Access Compliance Report

Public Rights-of-Way

(Curb Ramps)

Intersection ID: 15657	Main Street: CUMBERLAND_AV	Cross Street: LYNWAY_DR	Location:	N
ADA ID: BEED3A0ED86A	Ramp Type: PerpDiag	Initial Pass/Fail: Fail	Overall Compliance: No	Severity Score: 25
Codes/Mitigation Info/Possible Solution		Field Measurements/Component Compliance

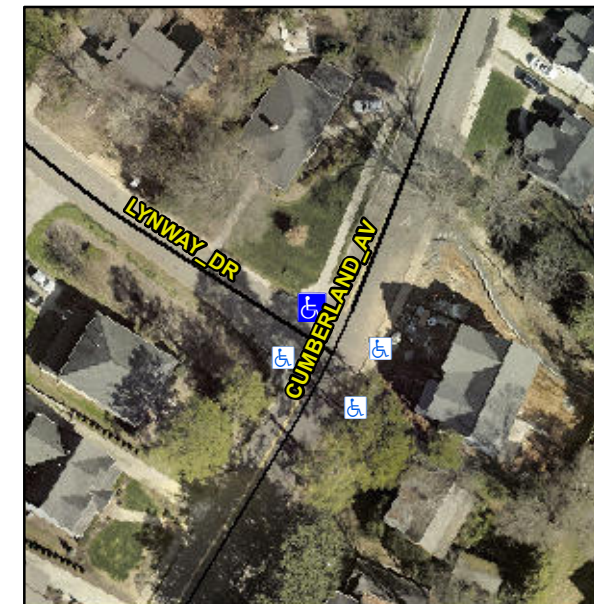
Not Found, R304.2.2, R304.5.3

Compliance	Description	Data	Compliance	Description	Data
N/A	Ramp Length (in)	79.0	No	Ramp Slope (%)	8.7
Yes	Ramp Width (in)	48.0	No	Ramp XSlope (%)	5.9
N/A	Flare Type LT	N/A	N/A	Flare Type RT	N/A
N/A	Flare Slope LT (%)	N/A	N/A	Flare Slope RT (%)	N/A
N/A	Flare Traversable LT?	N/A	N/A	Flare Traversable RT?	N/A
N/A	Landing Length (in)	N/A	N/A	DWS Provided?	N/A
N/A	Landing Width (in)	N/A	N/A	DWS Contrast?	N/A
N/A	Landing Slope (%)	N/A	N/A	DWS Length (in)	N/A
N/A	Landing X Slope (%)	N/A	N/A	DWS Full Width?	N/A
N/A	Landing Curb? (Y/N)	N/A	N/A	DWS Offset (in)	N/A
N/A	Shared Landing?	N/A			
N/A	Gutter Ponding?	N/A	N/A	Gutter Slope (%)	N/A
N/A	Gutter Lip Ht (in)	N/A	N/A	Gutter X Slope (%)	N/A
N/A	Painted X Walk1?	No	N/A	Painted X Walk2?	No
	X Walk 1 Direction	To SW		X Walk 2 Direction	To SE
N/A	X Walk 1 Width (in)	N/A	N/A	X Walk 2 Width (in)	N/A
	X Walk 1 Slope (%)	8.0		X Walk 2 Slope (%)	1.6
	X Walk 1 X Slope (%)	1.5		X Walk 2 X Slope (%)	6.4

N/A	Ramp inside XWalk1?	N/A	N/A	Ramp inside XWalk2?	N/A
	Road Slope (%)	5.2	N/A	Clear Space?	N/A
	Road X Slope (%)	8.1	N/A	Clear Space to XWalk (in)	N/A
N/A	Any Obstructions?	N/A	N/A	Storm Grate/Utility Hazard?	N/A
	Obstruction Type			Storm Grate/Utility Type	
		N/A			N/A
			Yes	Surface Condition? (G/P)	Good

Remove & Replace Curb Ramp With Two New Directional Ramps or Equivalent.
